# SERVICE BULLETIN

ENGINE - HP TURBINE - PROVIDE A NEW STAGE 2 HP TURBINE HUB ASSEMBLY WITH REVISED  
METERING PLUGS - CATEGORY CODE 6 - MOD.ENG-72-0101

V2500-ENG-72-0101

Location of Stage 2 HPT Metering Plug  
Fig.1

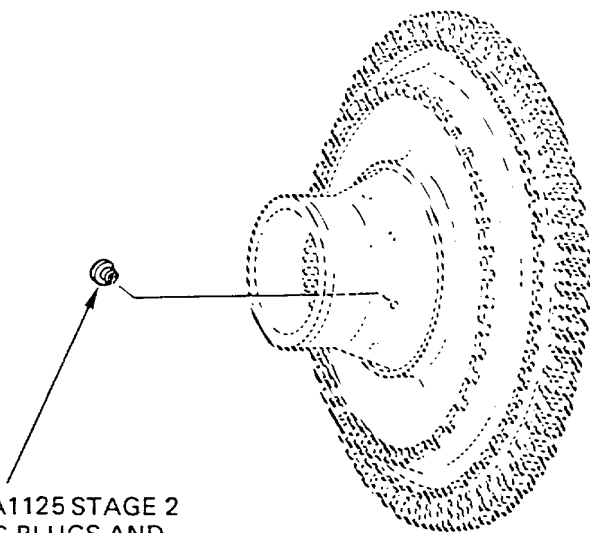
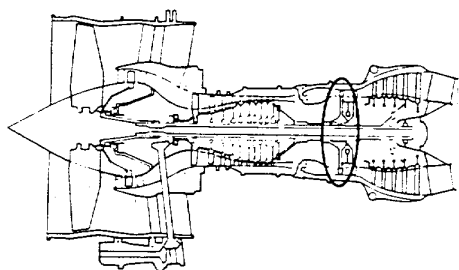
- (a) Assemble the Stage 2 Turbine Rotor Assembly by the approved procedure in Reference (3), Chapter/Section 72-45-30, Assembly. See Figure 1.

- (i) Use the 2A2403 Stage 2 HPT Metering Plug (4 off).

REMOVE PN 2A1125 STAGE 2  
HPT METERING PLUGS AND  
INSTALL PN 2A2403 STAGE 2  
HPT METERING PLUG (4 off)

Family Tree - Stage 2 Turbine Rotor Assembly  
Fig.2

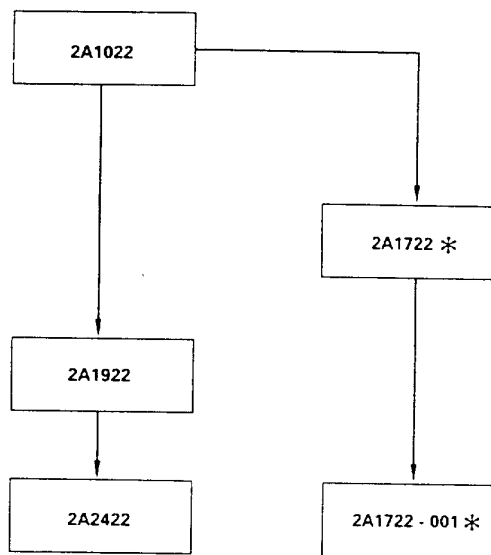
V2500 - ENG - 72 - 0011 \*  
ENGINE - HP TURBINE ROTOR  
AND STATOR ASSEMBLY - REWORK THE  
STAGE 2 TURBINE HUB ASSEMBLY  
TO INCORPORATE A TURBINE  
HUB HEATSHIELD

V2500 - ENG - 72 - 0075  
ENGINE - INTRODUCE RECONTOURED  
STAGE 1 AND 2 TURBINE ROTOR HUBS

V2500 - ENG - 72 - 0101  
ENGINE - HP TURBINE - PROVIDE A NEW  
STAGE 2 HP TURBINE HUB ASSEMBLY  
WITH REVISED METERING PLUGS
